**Submission from  
W. Turner, D. Raman and J. Walker**

Application for the renewal of the Nuclear  
Research and Test Establishment Operating  
Licence for the Chalk River Laboratories

# **An Evaluation of Canadian Nuclear Laboratories' Qualifications to Perform Licenced Activities**

A written submission in the matter of the  
Licence Renewal for  
Canadian Nuclear Laboratories,  
Chalk River Laboratories

***Figure 1 - Ensuring Safety (From CNL's Website)***

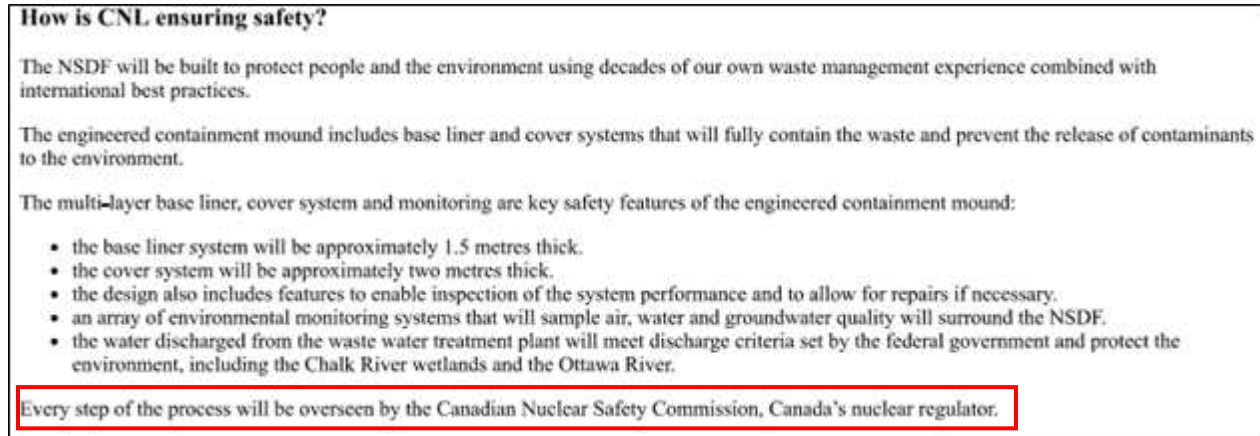
What is disturbing from this figure is the highlighted statement in which CNL's description of the role of the CNSC in ensuring safety. This statement suggests that CNSC is the gatekeeper.

**Figure 1 - Description of EA (From CNL's Website)**

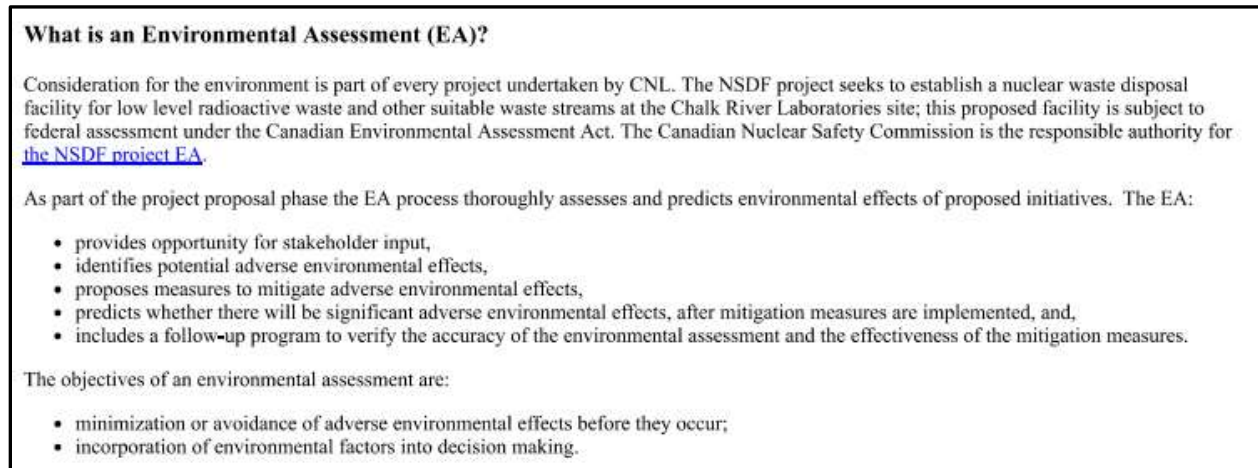
Figure 1 is a description of the EA process taken from CNL's website. This description suggests CNL is familiar with the process although one major issue is missing from this figure, the assessment of "alternative means".

In other words, in its proposals, CNL has not considered public input. Bullet 1 in Figure 1 has been ignored.

**Figure 5 - Generated Waste Volumes from 2016 (Overhead from CNL's Aug 3 Presentation)**

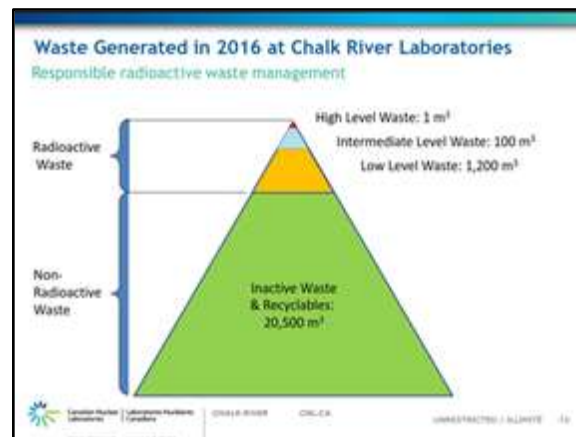
Figure 5 depicts a pyramid that purports to provide information about waste volumes generated at the CRL site during 2016. While interesting, it is problematic. The waste categories bear no relationship to the waste types as defined in the EIS. What it does suggest is that the waste problem at CRL is "Inactive Waste and Recyclables". Yet, CNL's proposed undertaking does not address this issue.

This leads to the obvious question, what is the purpose of this overhead? It appears to be deliberately misleading.

**Figure 7 - A Plan View of the Facility (From the Draft EIS report)**

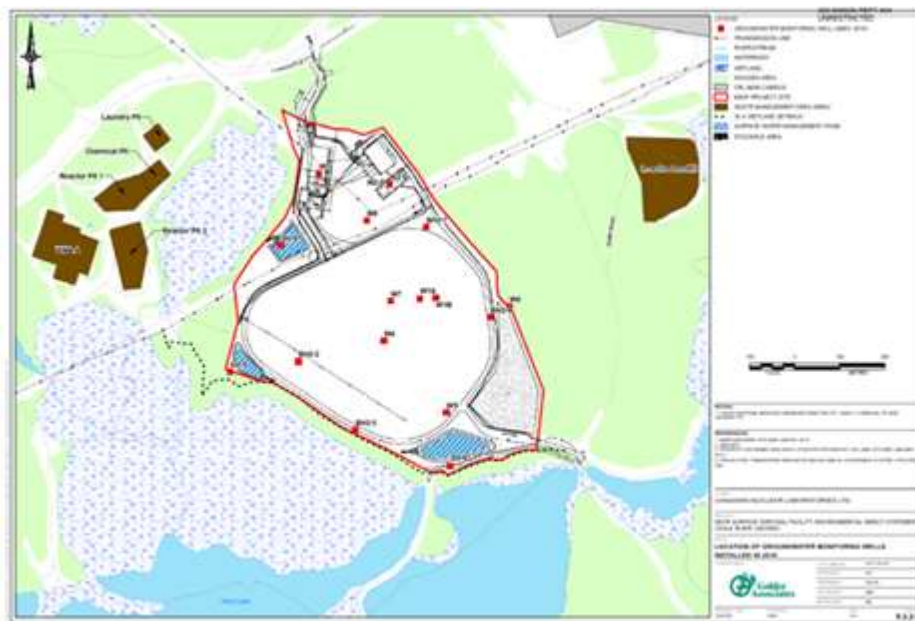
Several differences are obvious when the plan view depicted in Figure 6 (from the presentation) is compared to that depicted in Figure 7 (from the draft EIS report) and that in Figure 8 (from CNL's website copied 2017-09-30).

One obvious difference is the depiction of the wetlands. In Figure 6 and Figure 8, it is impossible to distinguish the wetlands from the forested areas. In Figure 7, it is obvious that the location of the proposed facility is near wetlands.

Aside from the difficulty in determining the facility's proximity to wetlands, there is the issue of its nearness to Perch Creek. Again, in Figure 6, this is difficult to determine. In Figure 8 the proximity to this environmental feature is not even depicted. However, in Figure 7, there is no doubt as to its location.

**Figure 9 – Cross-Section of the Proposed Facility (Overhead from CNL's Aug 3 Presentation)**

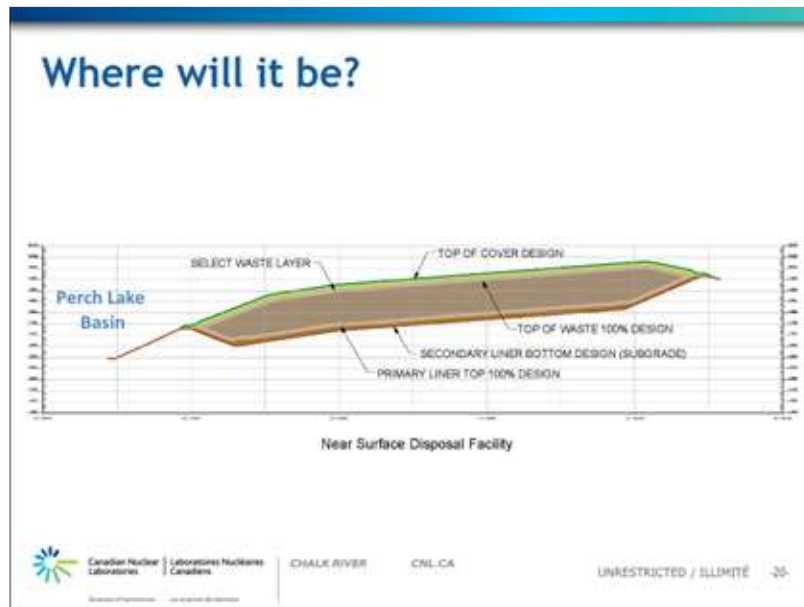
Figure 9 below appears to be the first depiction of the cross-section of the facility. This figure clearly depicts the slope of the mound. Further, the incline is towards the Perch Lake Basin.

What is disturbing about this figure is that nothing like it was included in the EIS, previous public information sessions, poster boards, CNL's website, and advertisements. All those previous figures are similar to another figure from the same August 3<sup>rd</sup> session in Chapeau Québec (see Figure 3). Without prior knowledge that the facility is inclined, it is difficult to discern this slope from an examination of Figure 3. Further, it is impossible to determine that the mound slopes towards the Perch Lake Basin.

In the EIS report [6], the term "hillside" does not occur anywhere. However, the CNL's presentation in Chapeau, Québec, August 3, included a depiction of the cross-section of the facility (see Figure 9). That figure clearly shows the hillside.

**Figure 10 - Comparison of the Volumes for Various Waste Facilities (from CNL's Website)**

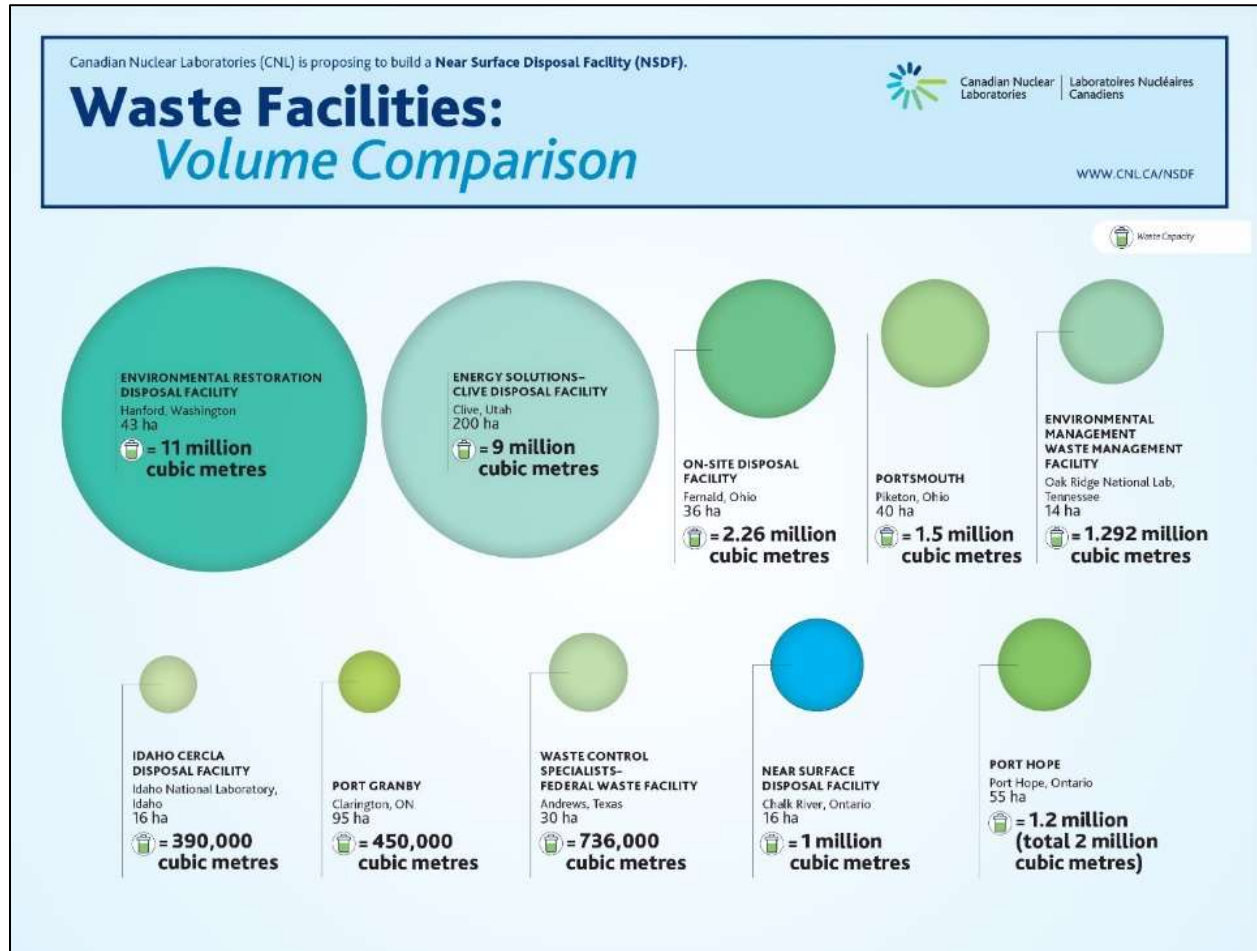
Figure 10, copied from CNL's website, provides a comparison of the volumes of various radioactive waste facilities. The following is an evaluation of this figure.

**Figure 11 - Description of CNL's Proposed Waste Disposal Facility (from CNL's Website)**

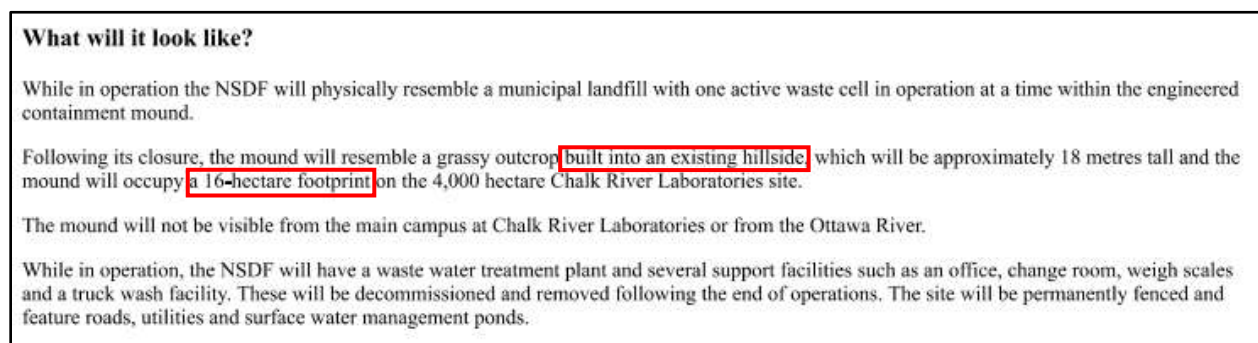
Figure 11, taken from CNL's website, describes the proposed mound. What is disturbing about this description is that several of the statements do not match the descriptions and/or the depictions of the mound included in the EIS.

In Figure 11, the footprint of the facility is given as 16 ha. However, in the EIS [6], that same footprint is given as 34 ha, over twice that given this figure.

**Figure 13 - NPD Poster 3 (Downloaded from CNL Website, 2016-11-01)**

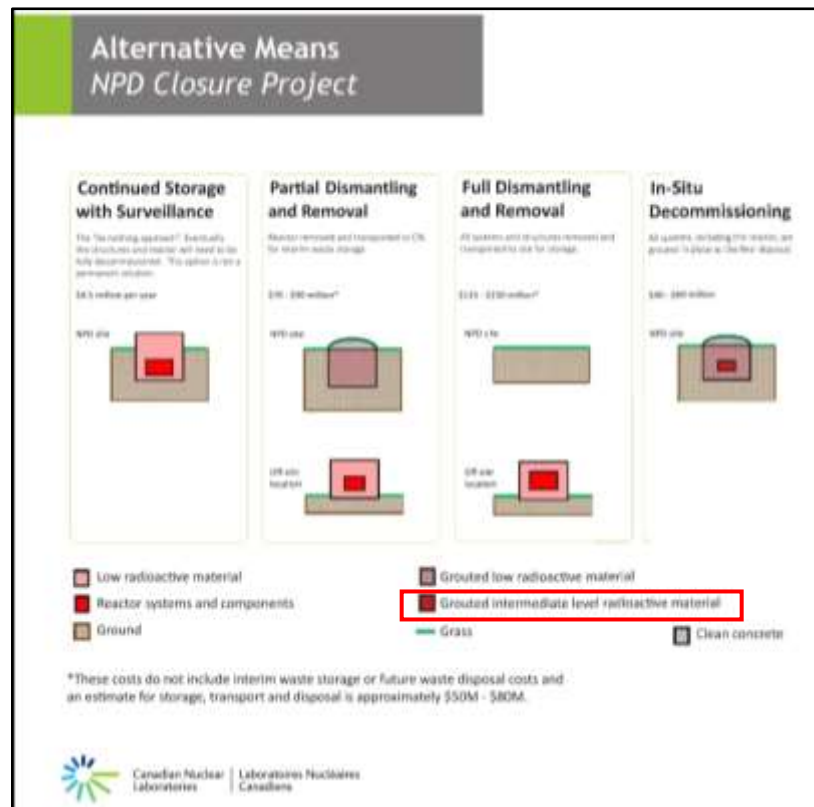
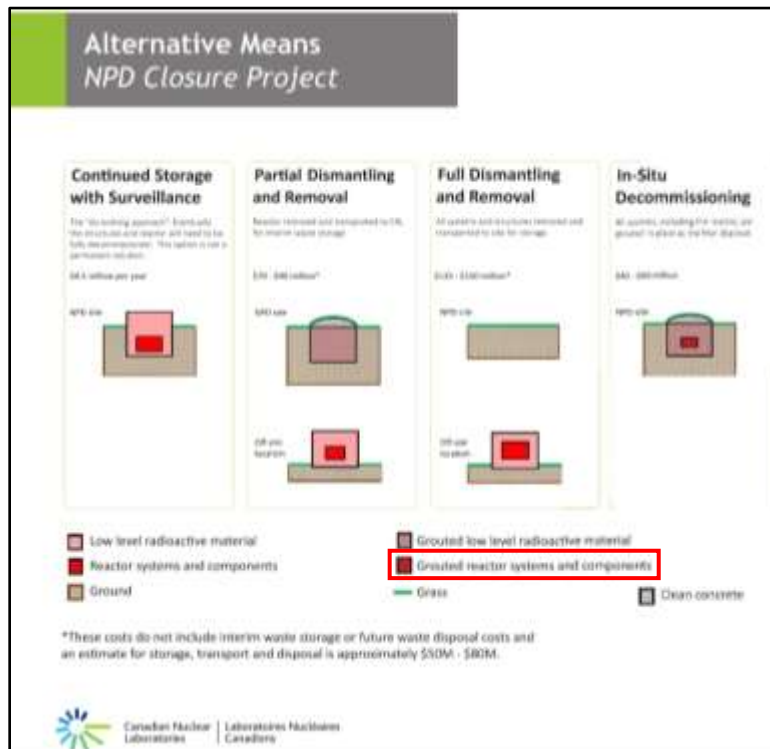
CNL's Mound project is not the only undertaking by CNL that has some disturbing miscommunication issues. The following short discussion compares two posters outlining the alternative means for CNL's NPD entombment project. Figure 13 depicts the Poster 3 downloaded from CNL's website on November 1, 2016. Highlighted is the legend box, "Grouted intermediate level radioactive material". This poster is no longer available from the CNL website.

Figure 14 depicts the same poster (Poster 3) only it was downloaded from CNL's website January 10, 2017, approximately 2 months later. This time the highlighted legend box has changed from "Grouted intermediate level radioactive material" to "Grouted reactor systems and components".

It appears that CNL became somewhat sensitive to the term "intermediate level radioactive material" and toned down the terminology to something less controversial. This appears to be deliberately misleading.
